SUBJECT: ISSUANCE OF AMENDMENT NO. 39 TO FACILITY OPERATING LICENSE
NO. NPF-29 - GRAND GULF NUCLEAR STATION, UNIT 1, REGARDING
CYCLE 3 FUEL RELOAD (TAC NO. 66376)

AMENDMENT TO FACILITY OPERATING LICENSE

Amendment No. 39
License No. NPF-29

SUPPORTING AMENDMENT NO. 39 TO FACILITY OPERATING LICENSE NO. NPF-29

FIGURE 3.2.1-1a MAXIMUM AVERAGE PLANAR LINEAR HEAT GENERATION RATE (MAPLHGR) VERSUS AVERAGE PLANAR EXPOSURE FOR ANF FUEL TYPE ANF299E5G3S8

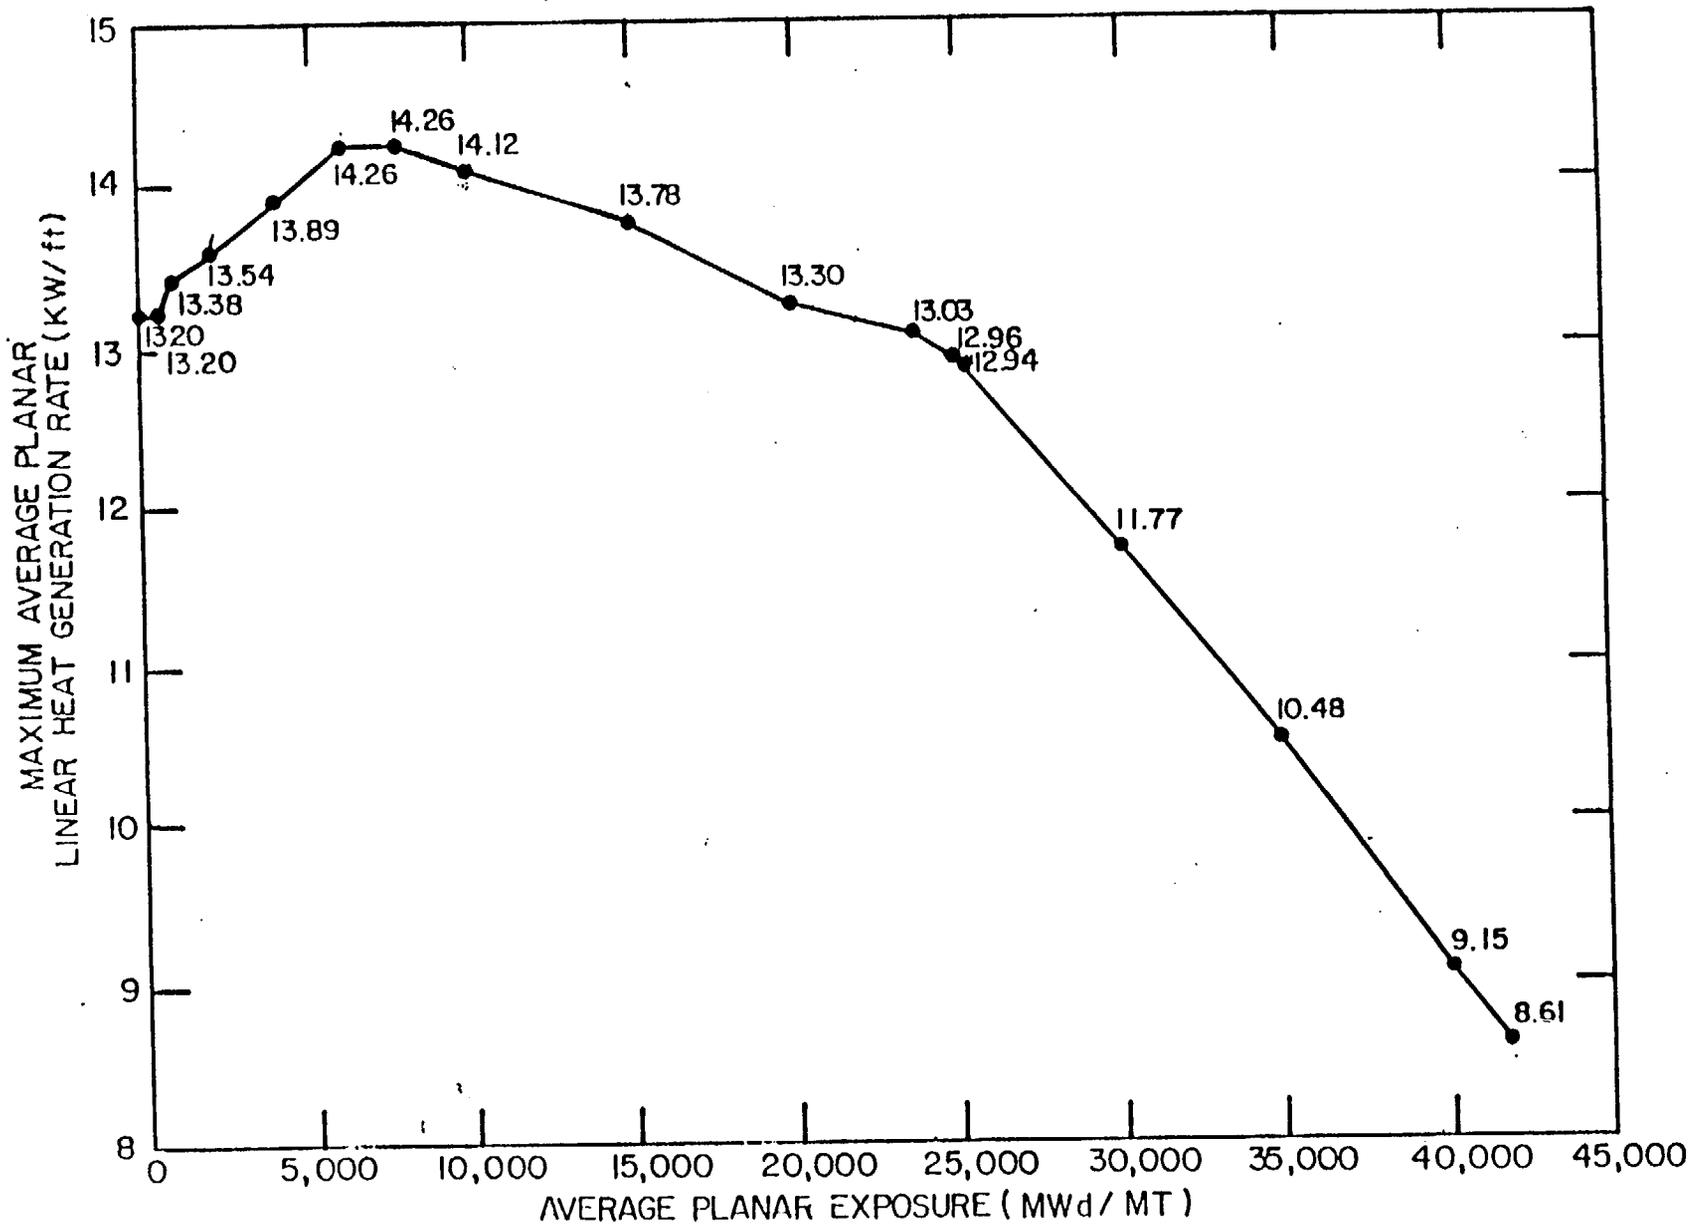
The amendment adds two maximum average planar linear heat generation rate (MAPLHGR) curves for two new types of fuel assemblies being loaded into the core for fuel cycle 3 and removes one MAPLHGR curve for a type fuel assembly being unloaded. Also, the average planar exposure limit is increased from 25,000 megawatt days per short ton (MWD/ST) to 28,500 MWD/ST. In addition, administrative changes were made to reflect the new fuel types and to correct an error in Figure 3.2.1-2.

3.2.1 During two loop operation all AVERAGE PLANAR LINEAR HEAT GENERATION RATES (APLHGRs) for each type of fuel as a function of AVERAGE PLANAR EXPOSURE shall not exceed the limits shown in Figures 3.2.1-1, 3.2.1-1a, 3.2.1-1b, or 3.2.1-1c as multiplied by the smaller of either the flow-dependent MAPLHGR factor ($MAPFAC_f$) of Figure 3.2.1-2, or the power-dependent MAPLHGR factor ($MAPFAC_p$) of Figure 3.2.1-3.

FIGURE 3.2.1-3 MAPFAC_p

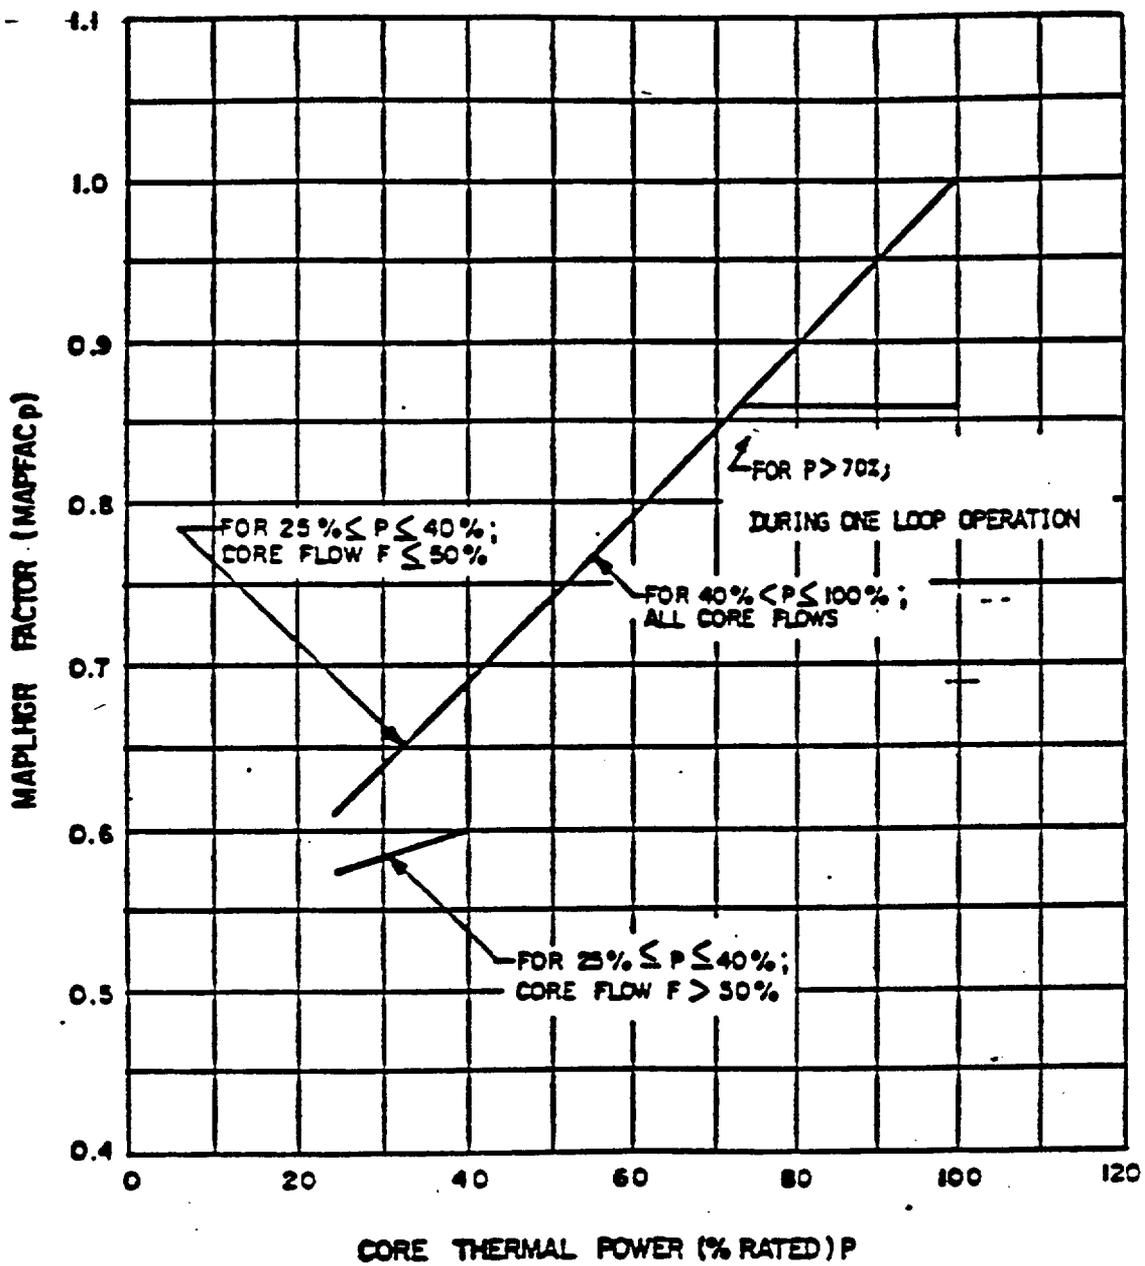
In Figure 3.6.1-3, the limiting MAPLHGR factor for power greater than 70% is incorrectly drawn at 0.84 instead of 0.86. Redrawing the limiting line at 0.86 is, therefore, acceptable.
